***Impact Study Addendum for
Generation Interconnection
Request
GEN-2005-017***

***SPP Tariff Studies
(#GEN-2005-017)***

November 2007

Figure 1. – Interconnection Facilities

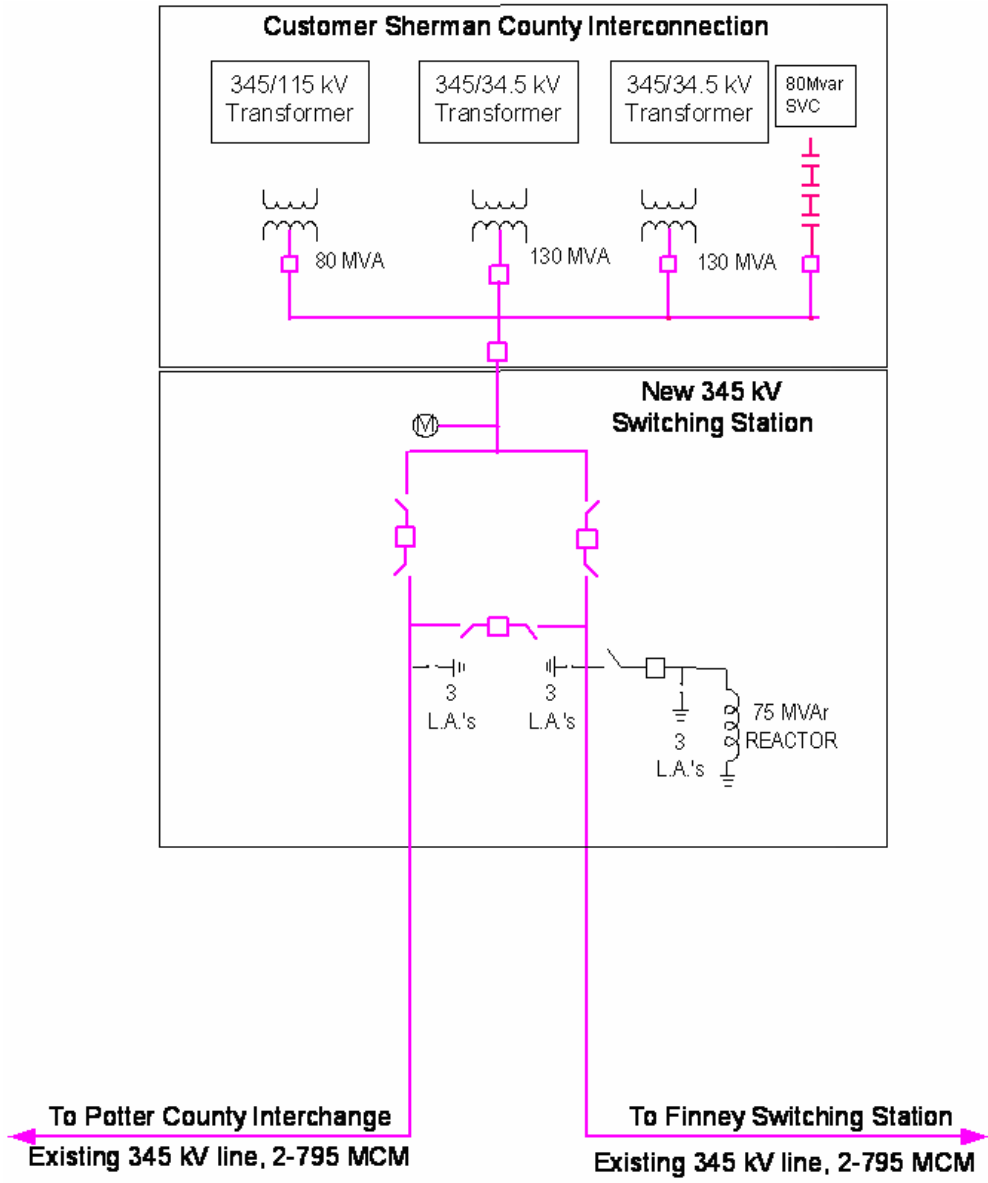
The requirements for interconnection of the 340MW wind farm consist of building a new 345kV ring bus with three terminals, one each to Potter County Interchange, Finney County Interchange (or a prior queued wind farm), and one to the Customer wind farm. This station will be constructed, owned, and maintained by SPS. The Customer's facility will consist of a 345kV line that will connect the 345kV switching station to a 345/115/34.5kV substation to be built, owned, and maintained by the Customer. The Customer 345/115/34.5kV substation will have two 345/34.5kV substation transformers and a 345/115kV transformer. Each of the two 345/34.5kV transformers will collect the energy from approximately eighty-six (86) General Electric 1.5MW wind turbines for a total power output of 129MW for each transformer. The 345/115kV transformer will connect to a 115kV line that will interconnect into a second Customer substation with a 115/34.5kV transformer. The second Customer substation will collect the energy from fifty-three (53) General Electric 1.5MW wind turbines for a total output of 79.5MW. The wind farm will have a total output of 339MW.

The 345kV switching station will also include a 345kV line reactor on the terminal looking toward GEN-2002-008 (Finney). The size of this line reactor is determined by whether the two prior queued projects come off of suspension. These costs can be seen in Table 1.

If both prior queued request come off of suspension and are eventually built, combined with this request there will be over 770MW of wind generation on the 345kV line section between Potter and Finney. There will also be over 200MVar of line reactors on this line section. Due to these considerations, a static var compensator device (SVC) will be required by the Customer to be installed at the Customer's 345kV substation. This is a change from the original Impact Study that placed this SVC at the switching station for GEN-2002-008. This device is necessary to prevent possible voltage collapse for an outage of the 345kV line from wind farm – Potter 345kV. This SVC device will be constructed, owned, and maintained by the Customer. This SVC device has been sized at 80Mvar and will be placed on the 345kV bus at the Customer switching station

The final determination was made to move the SVC that was originally placed at GEN-2002-008 to the Customer substation, GEN-2005-017. The SVC should be placed on the 345kV bus as the Customer wind turbines and capacitor banks are already placed on 34.5kV and 115kV buses. In addition, static capacitor banks should be installed at the switching station for GEN-2003-013. These banks should be sized at 32Mvar total capacitance. By placing the capacitor banks at GEN-2003-013, it allows the GE turbines at this wind farm to use their dynamic reactive capability only in the case of a severe contingency.
